Grand Coulee's Third Powerplant 500-kilovolt Transmission Line Replacement Project

Revision Sheet for the Environmental Assessment
Finding of No Significant Impact
Mitigation Action Plan

DOE/EA-1679
December 2011

Figure 1. Areas of ground disturbance associated with the Preferred Alternative.

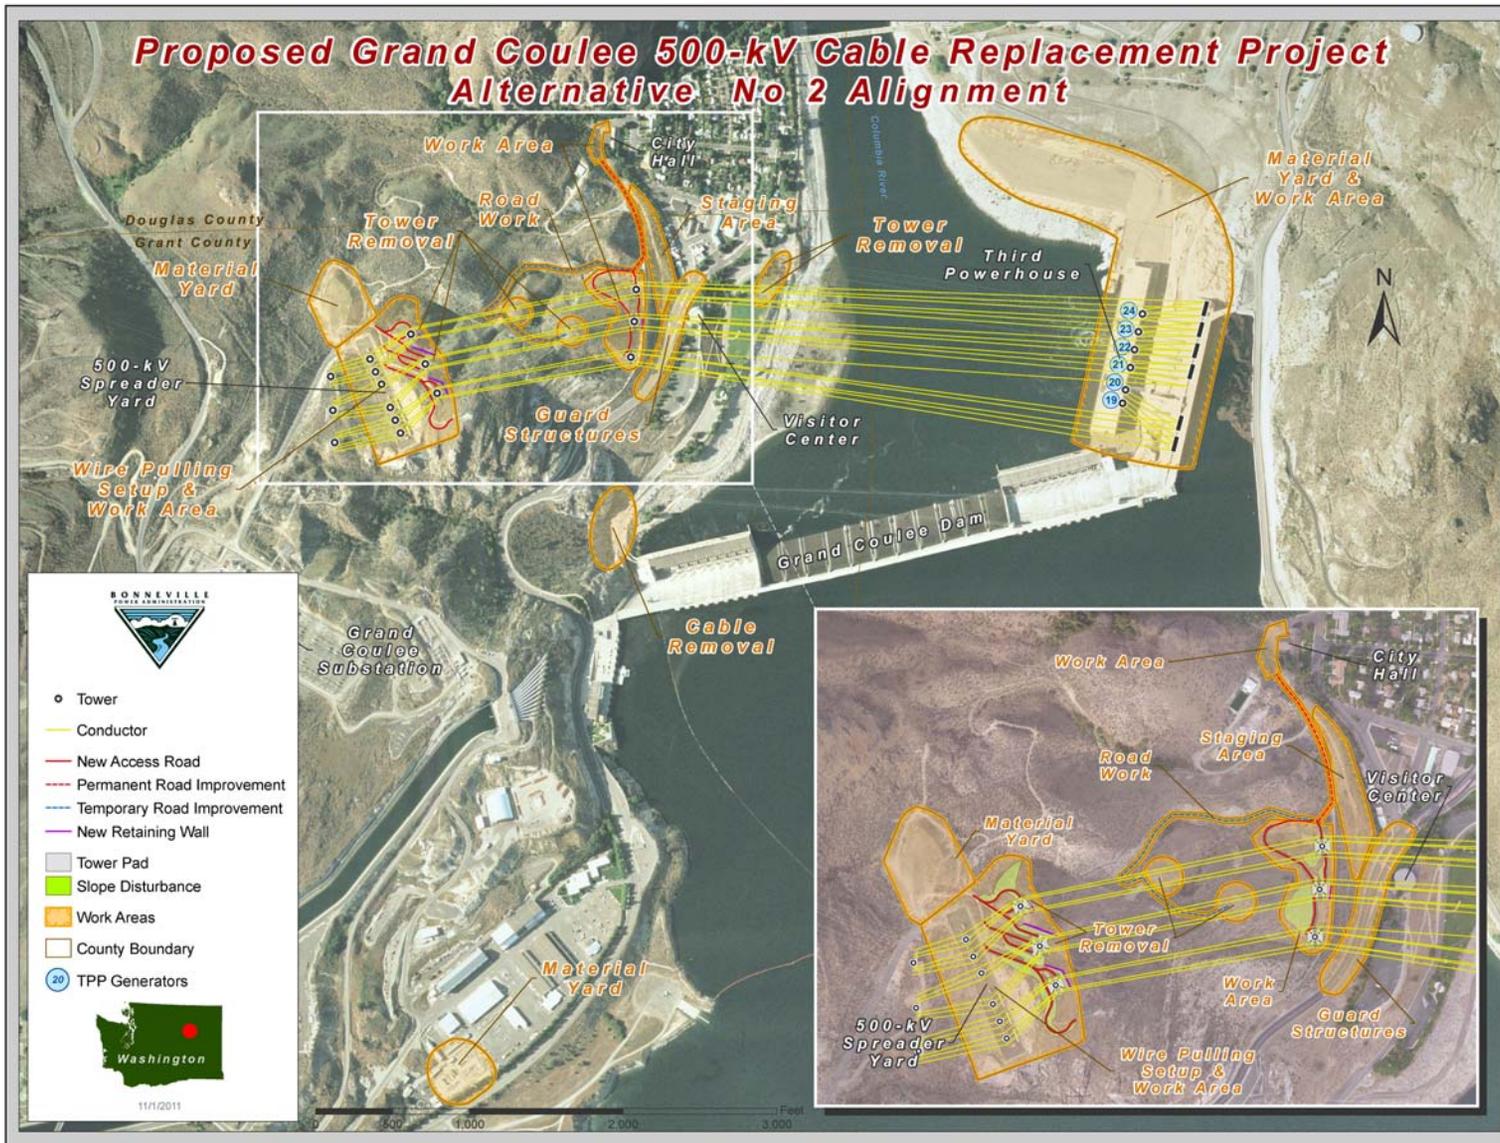
Additional changes to the EA include updating Figure 2-3 on Page 2-6 with the following figure (*Figure 1*):

Areas of ground disturbance and the acreage associated with the construction activity have also been updated and corrections to the EA have been made in the following sections:

Figure 2. Double-circuit 500-kV towers for the proposed Grand Coulee Line Replacement Project.

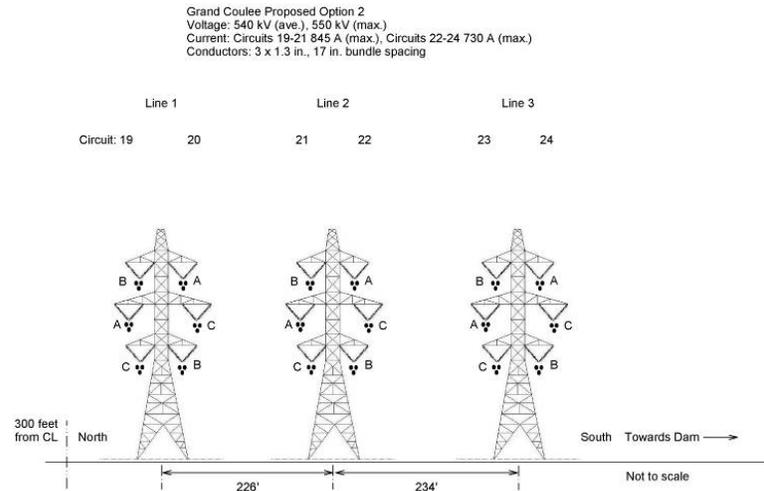
j. Comment: *How many transmission lines are in the project?*

Response: There would be 6 lines with a total of 54 transmission lines (conductors) spanning across the Columbia River from the Third Powerplant to the 500-kV Spreader Yard. Figure 2 below depicts how the proposed lines will be laid out once the proposed lines meet the first set of towers on the Upland Slope above SR 155.

As described in Chapters 1 and 2 of the Preliminary EA, each of the six turbine generators within the Third Powerplant (TPP) (G-19 through G-21) actually have one circuit that originates from them, which is then translated to 9 transmission lines (conductors) that originate from the TPP (one circuit is equal to three phases (A, B and C); therefore, three transmission lines exist per turbine generator and there are six turbine generators within the TPP). Each phase of the 6 lines will be triple-bundled as shown in Figure 2 above which in turn equals to 54 transmission lines or conductors. Although not shown in Figure 2 above, there also will be 10 overhead ground wires attached to the towers depicted in Figure 2.
